PLANT HATCH - UNITS 1, 2  
NRC DOCKETS 50-321, 50-366  
OPERATING LICENSES DPR-57, NPF-5  
RESPONSE TO REQUEST FOR ADDITIONAL  
INFORMATION ON THE PRESSURE SENSOR  
ACTUATION SYSTEM FOR SAFETY RELIEF VALVES  
NRC TAC Nos. M82709, M82723

By letter dated April 8, 1992, you requested additional information regarding our proposed pressure sensor actuation system for the main steam safety relief valves. The enclosure to this letter provides answers to the two specific questions as discussed in our April 2, 1992, telephone conference.

PLANT HATCH - UNITS 1, 2  
NRC DOCKETS 50-321, 50-366  
OPERATING LICENSES DPR-57, NPF-5  
RESPONSE TO REQUEST FOR ADDITIONAL  
INFORMATION ON THE PRESSURE SENSOR  
ACTUATION SYSTEM FOR SAFETY RELIEF VALVES  
NRC TAC Nos. M82709, M82723

FIGURE 1

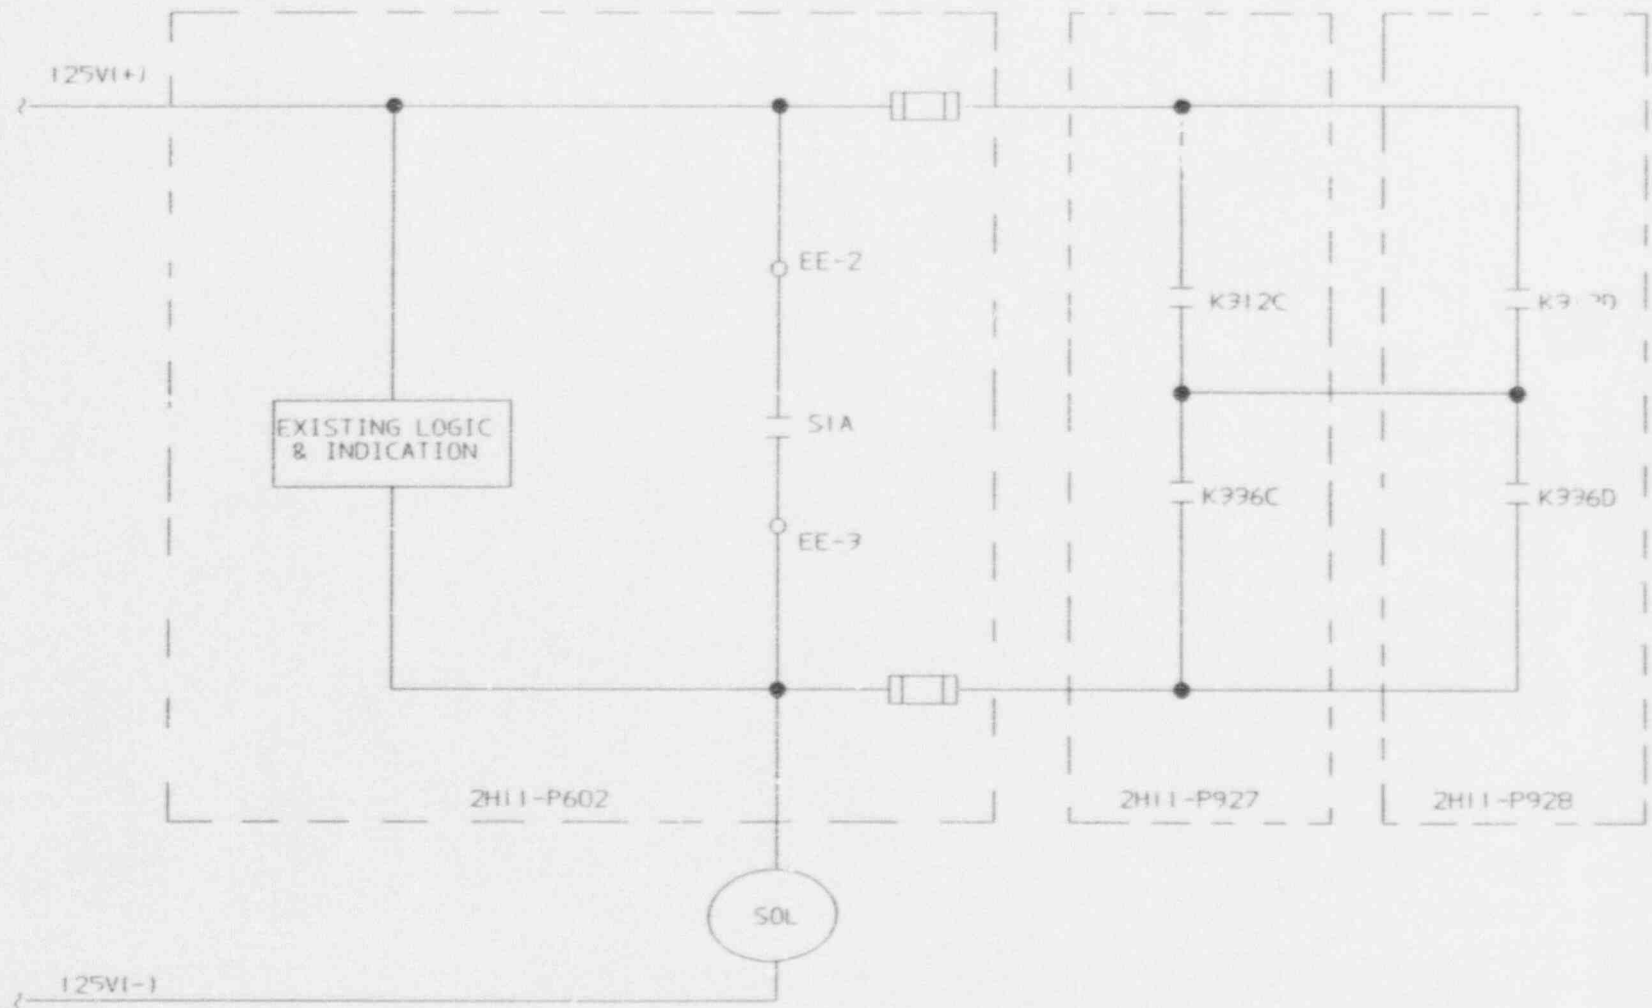
QUESTION: Please discuss the Emergency Safety System Division I to Division II interface criterion mentioned in Item 4 of the Narrative Design Summary. Also, justify the use of fuses as isolations between redundant divisions. Include in your justification a description of why such an interface is necessary and how the fuses were qualified to accomplish this task. Furthermore, discuss the periodic testing of these fuses to provide assurance that redundant Class 1E power sources will not be subjected to a single failure.

RESPONSE: It is our intention that the safety relief valve pressure sensor actuation modification be a nonsafety related addition and serve as a backup to the existing safety related system. In order to assure that this modification will not have an adverse impact on the existing safety related system, we are providing fuses to isolate the new, non-safety related logic from the existing logic (see attached figure nos. 1-3). Equipment procured for this modification, including fuses, will meet Class 1E and seismic

requirements. These fuses are not used to provide divisional separation. Divisional separation will be provided by coil-to-contact separation in the relays used to provide signal initiation to the valve. Circuits providing contact interconnections will be routed in existing divisional raceways with separation being maintained. These fuses will be included in the existing site maintenance program.
